S E R V I C E N O T E

Supersedes:
E8364A-03

E8364A PNA Microwave Network Analyzers

Figure 1: A3 Front Panel Interface Board Assy without the Bracket

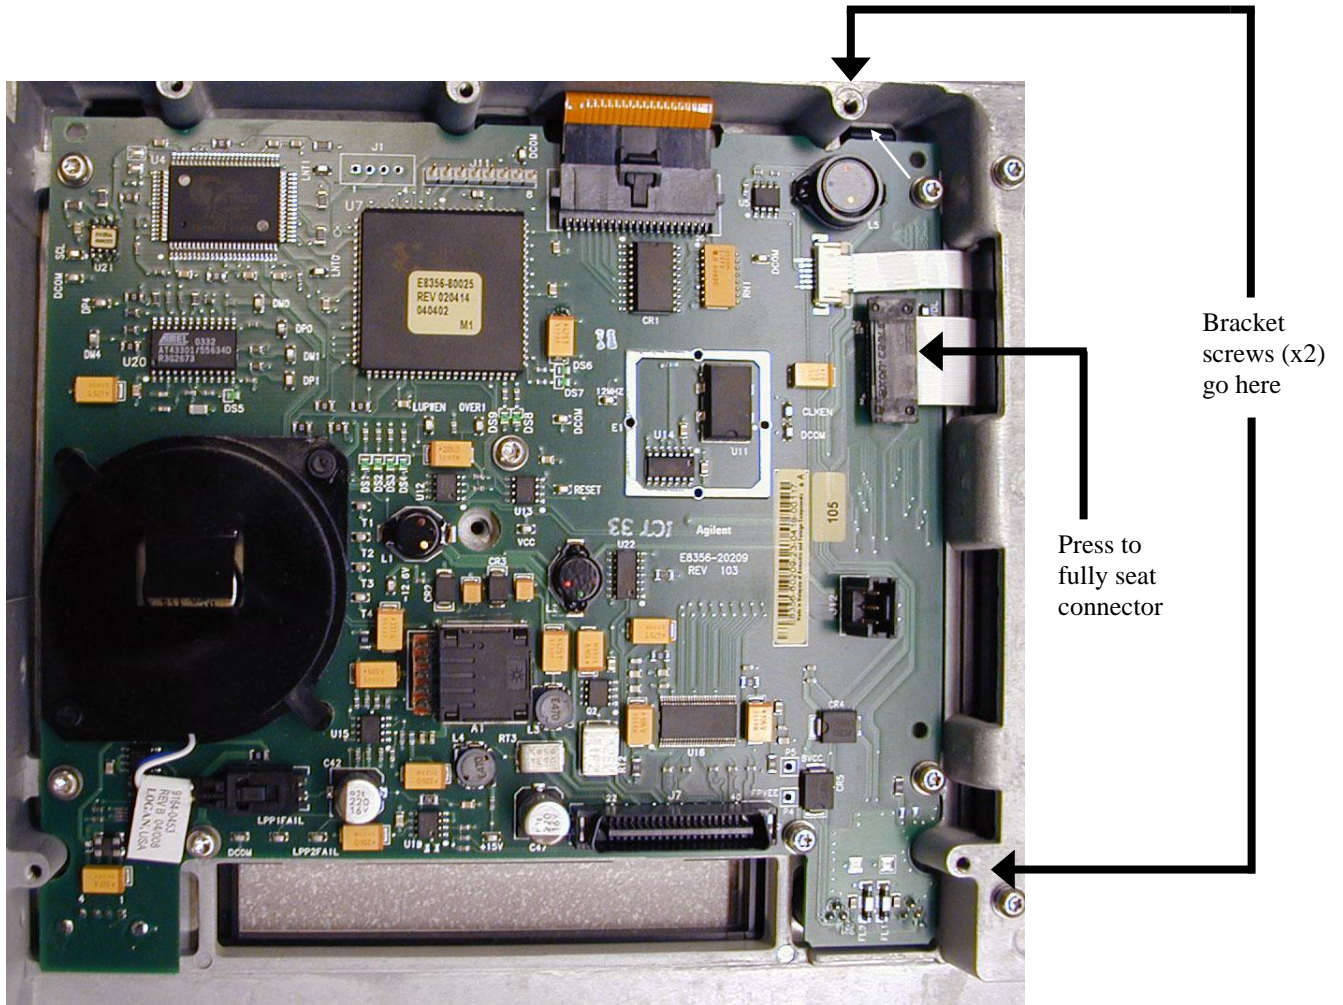
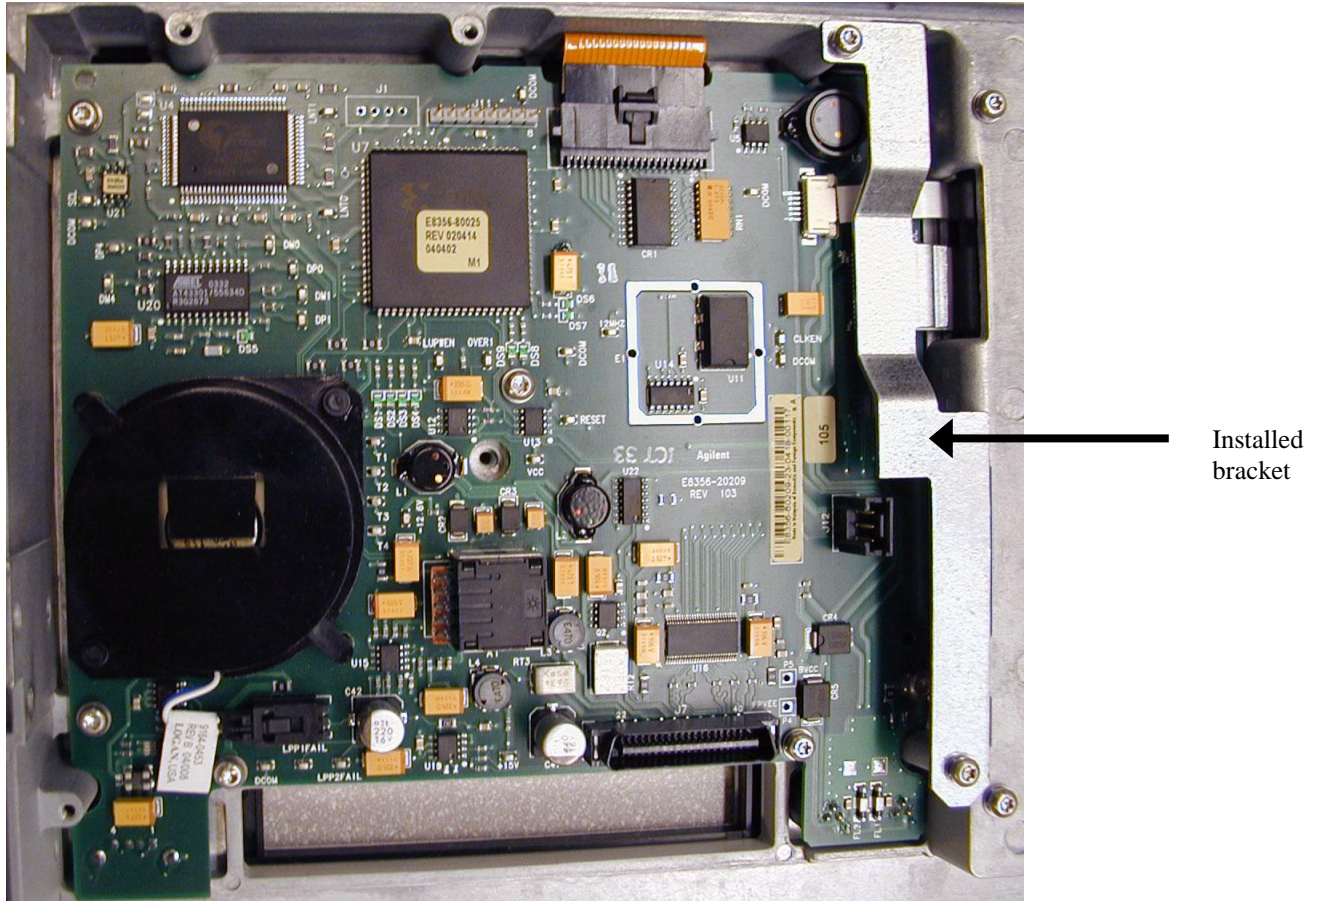
A connector of the ribbon cable (Agilent part number 8120-8409) that joins the front panel display to the front panel interface board can loosen, causing a display failure, unless a new bracket is installed. Because the failure rate has been very low, it is recommended that the bracket be installed only when there is an additional reason to remove the PNA front panel.

1. Refer to Figure 1 in this document:
 - Press down firmly on the ribbon cable's black connector.
 - Locate the two tapped holes for the bracket screws.
2. As shown in Figure 2 in this document, position the bracket so that its holes line-up with the two holes you located in the previous step.
3. Hand-start the two screws, and then torque both to 9 in-lbs.
4. Reinstall the PNA Front Panel by following the Service Guide instructions in the "Replacement Procedure." This is located on the same page as the "Removal Procedure" used previously in step 7.
